# MARCO POLO - 101 W 33RD STREET

Date	Description
05.19.2022	Progress Set

1 UNIT PLAN - END UNIT W/ RISER ROOM (TYPE B ADA UNIT - 1ST FLOOR ONLY)  
3/8" = 1'-0"

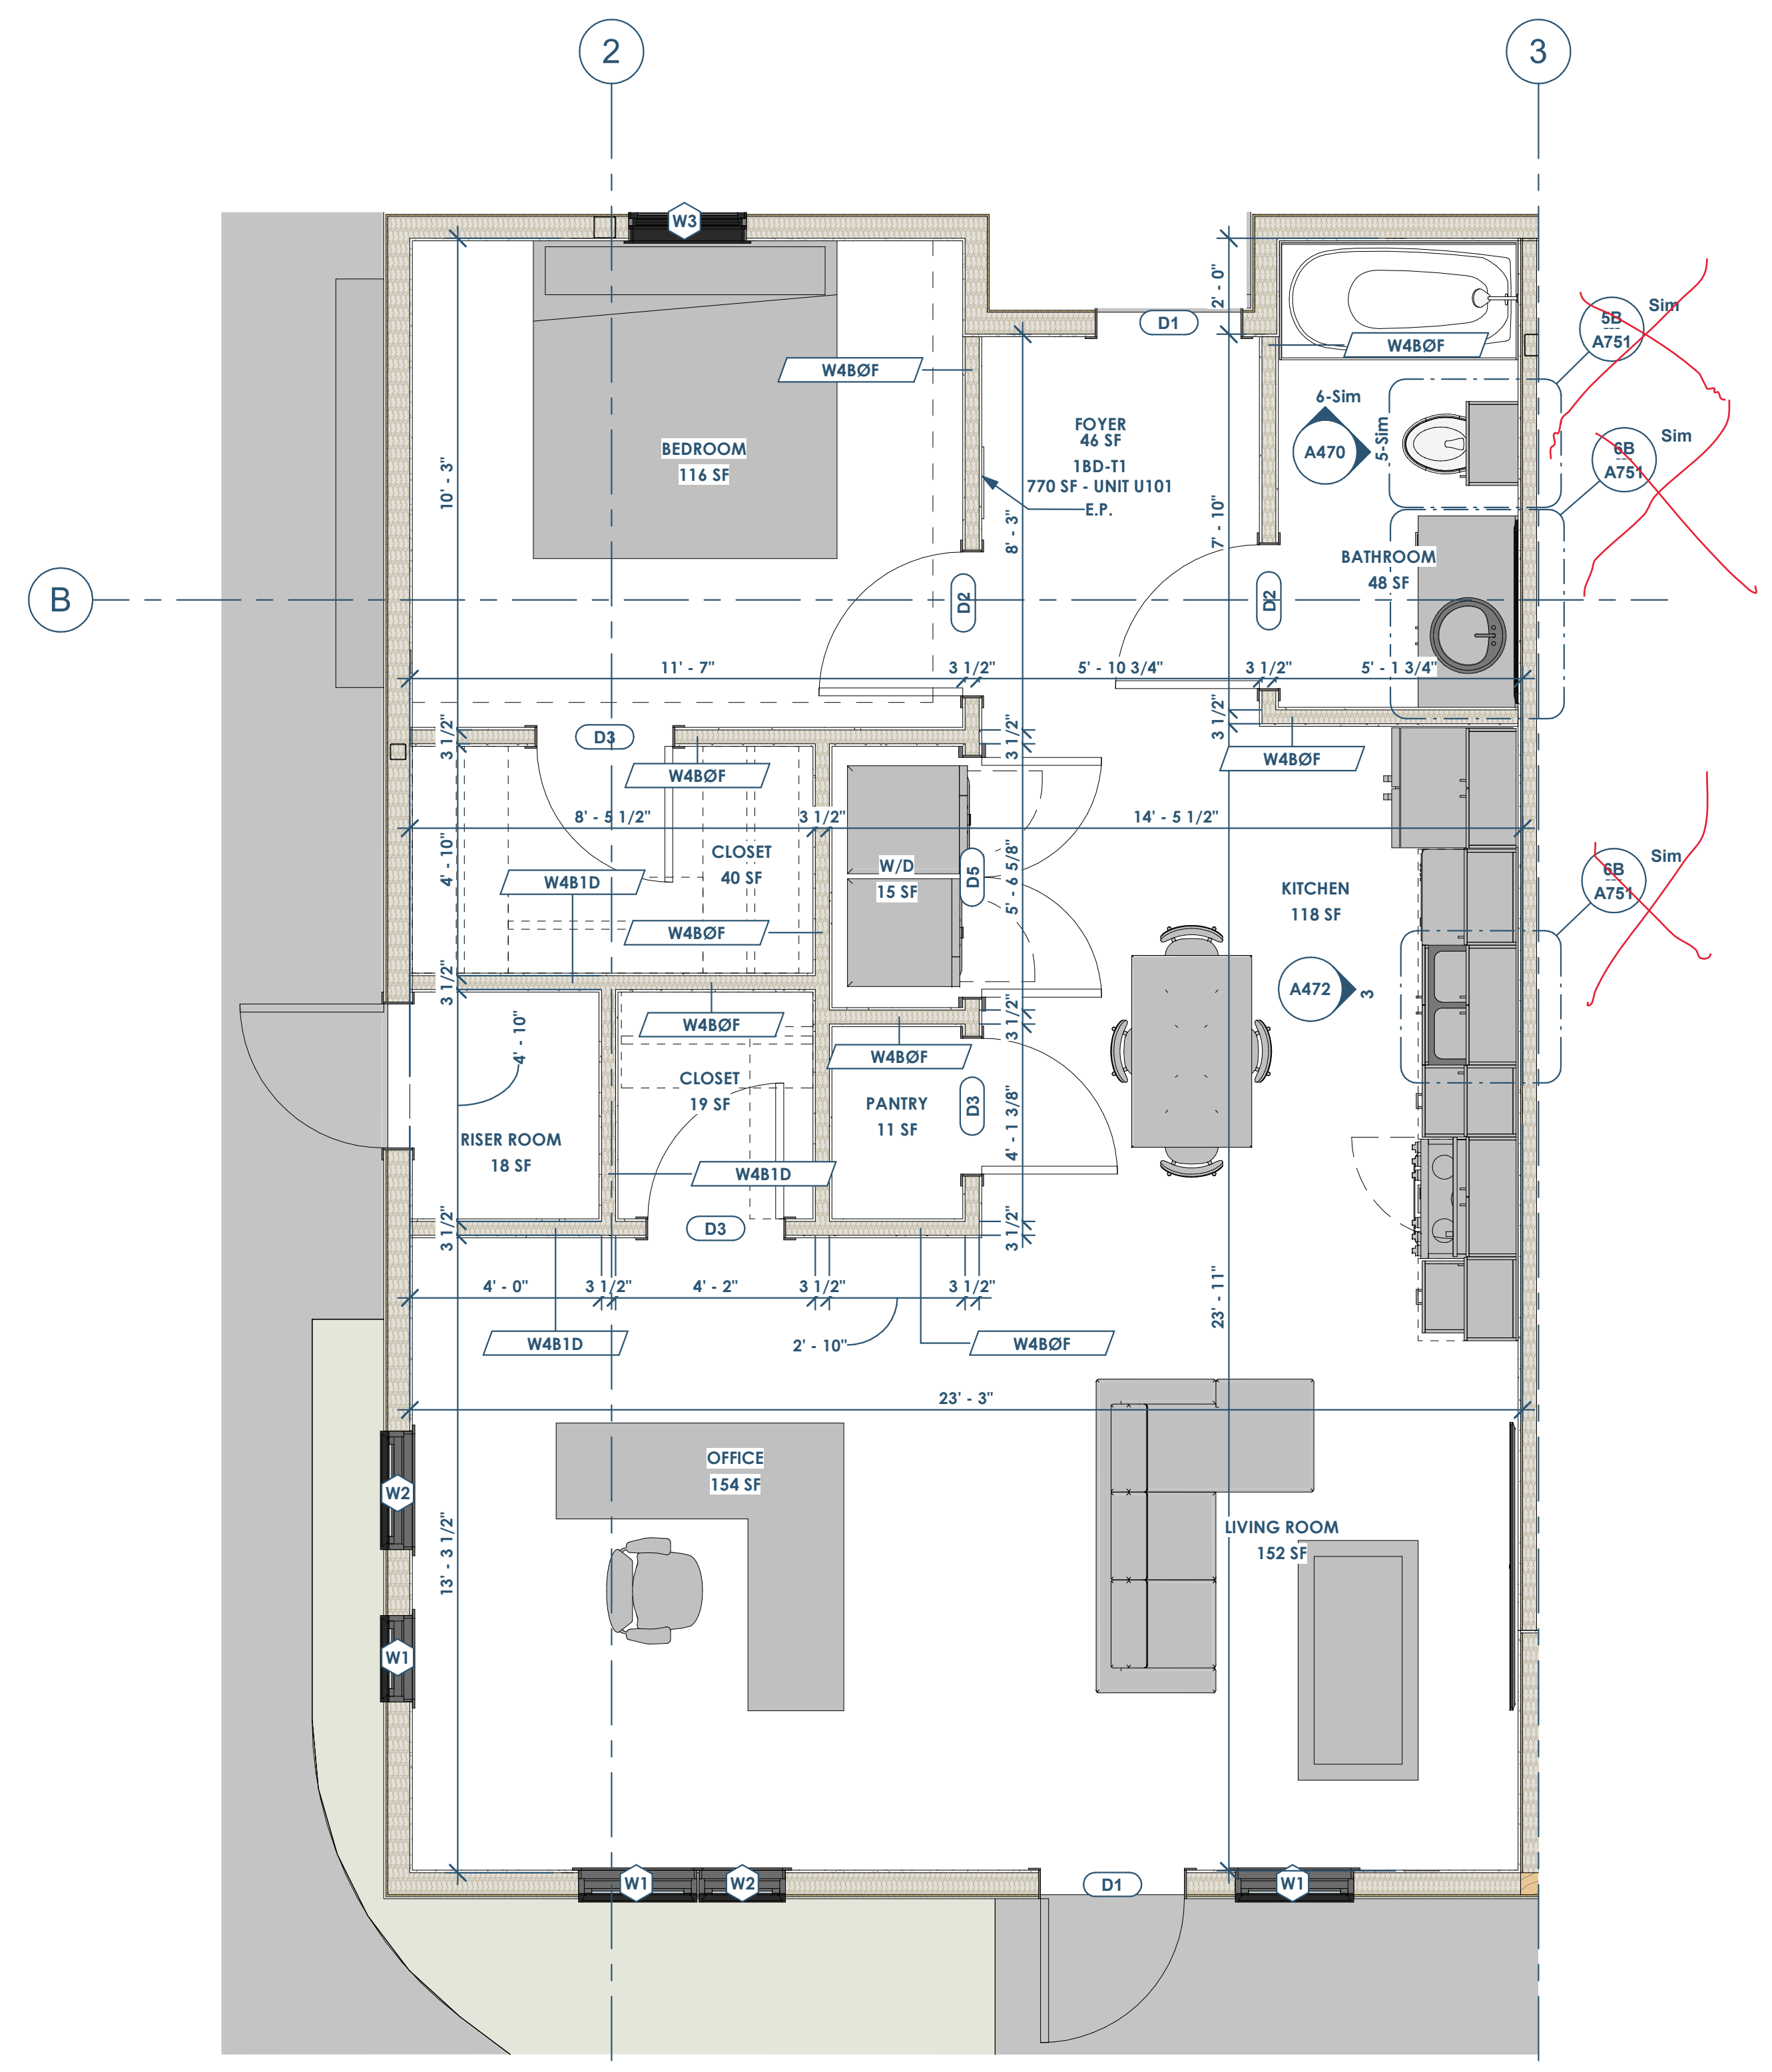
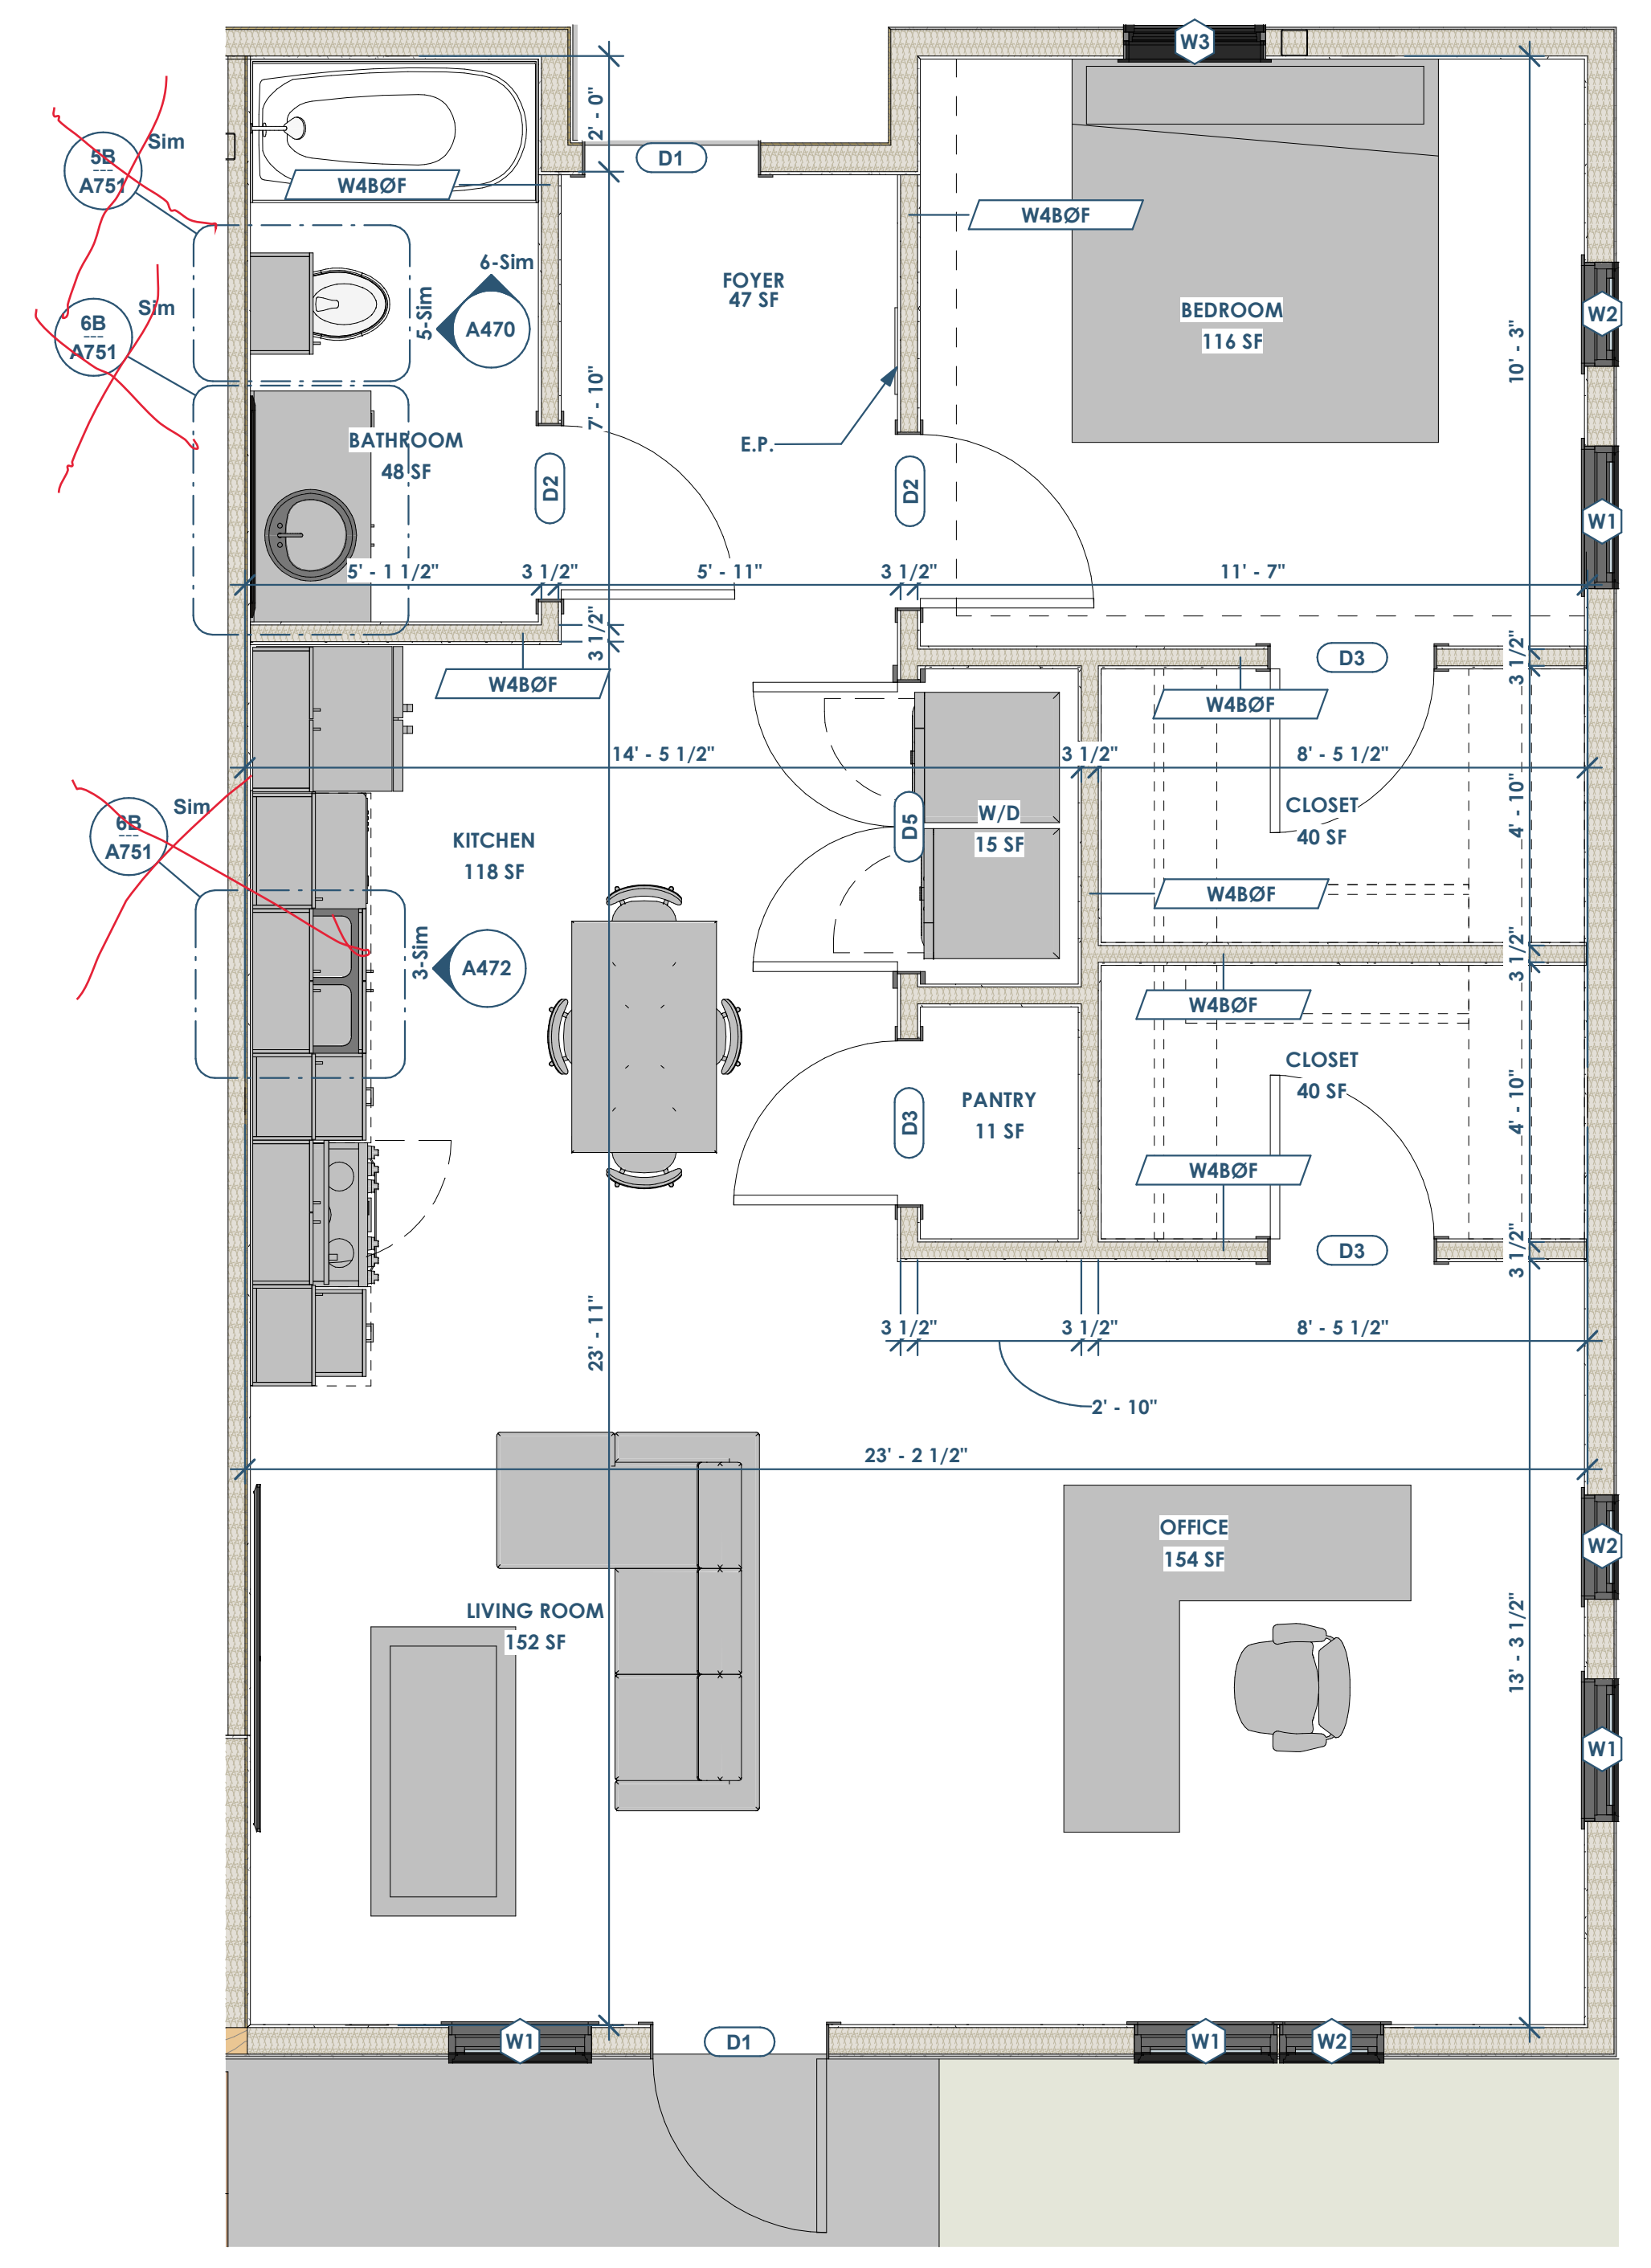
REFERENCE COMMENTS AND ADD NOTES PER A470.
